Addendum 3

ITB #23-62-211309

Seward Coal Dock –Loading Equipment Demolition

SEWARD, ALASKA
ALASKA RAILROAD CORPORATION
SEWARD DOCK FACILITIES
POST DREDGE AND CLEARANCE SURVEY
MAY 2, 2008

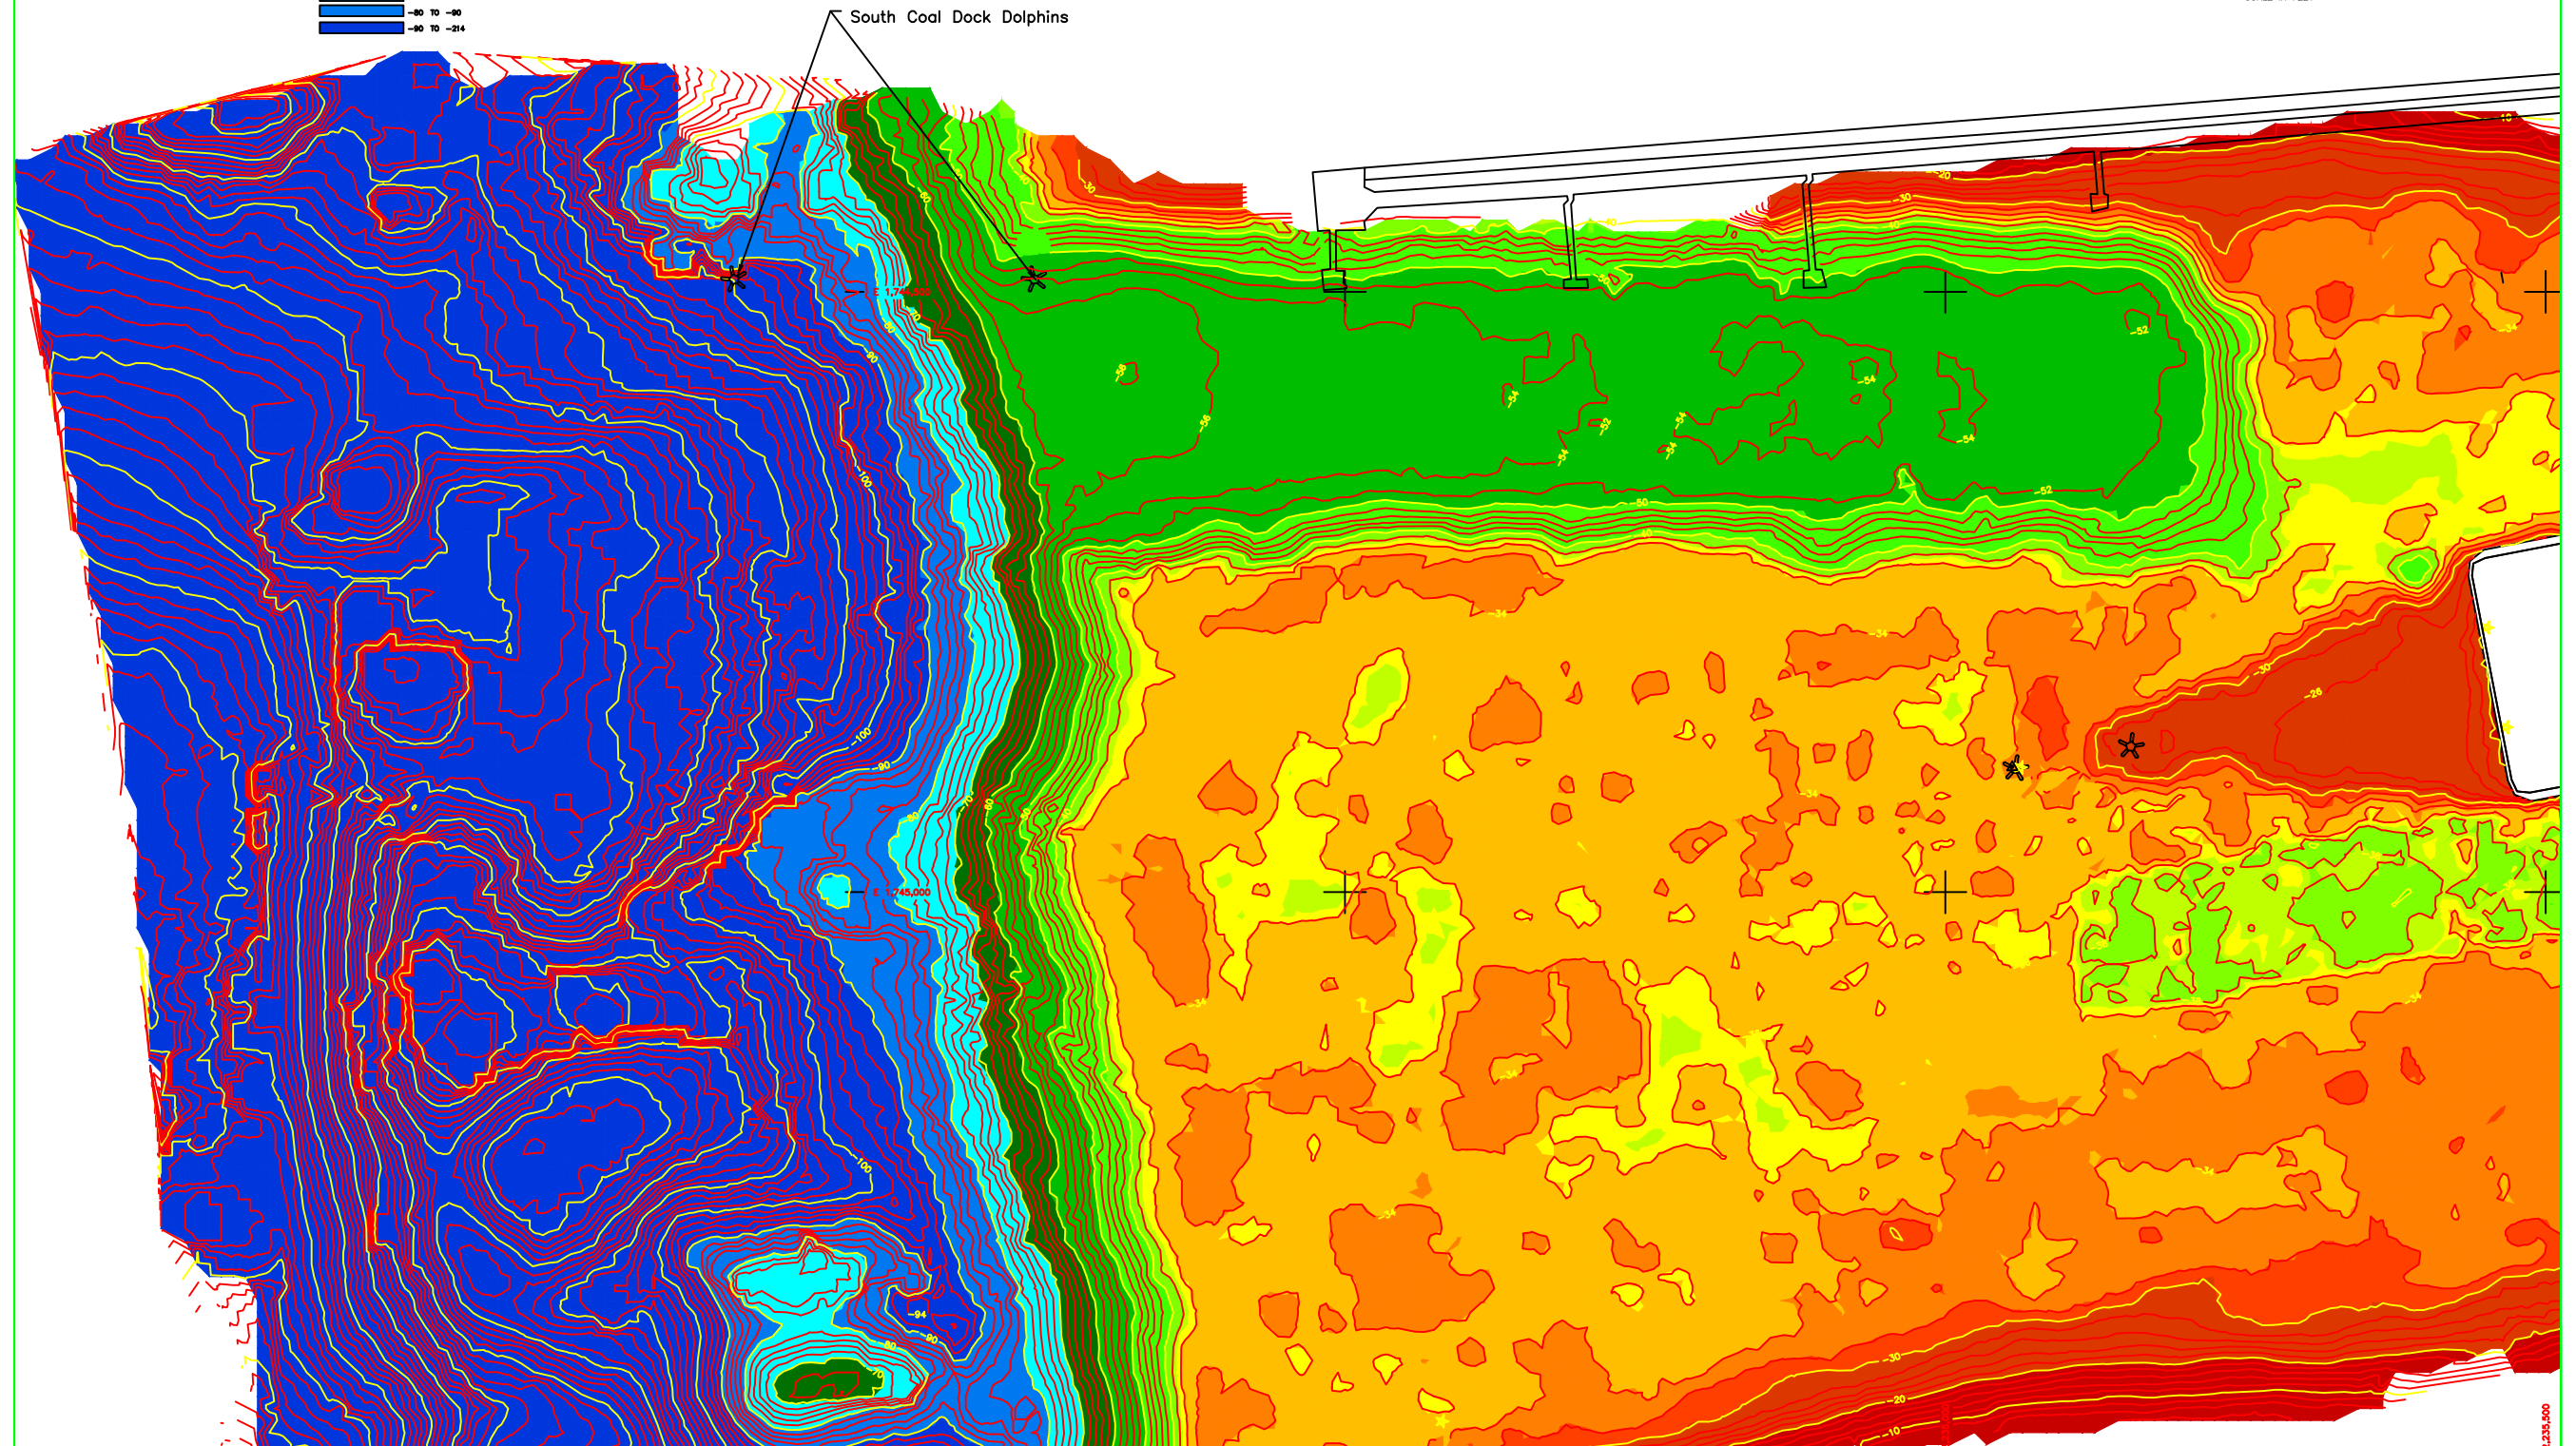
- Can ARRC provide current bathymetry data for the area around and between the coal ship loading terminal and the cruise ship terminal?
Yes, see attached document
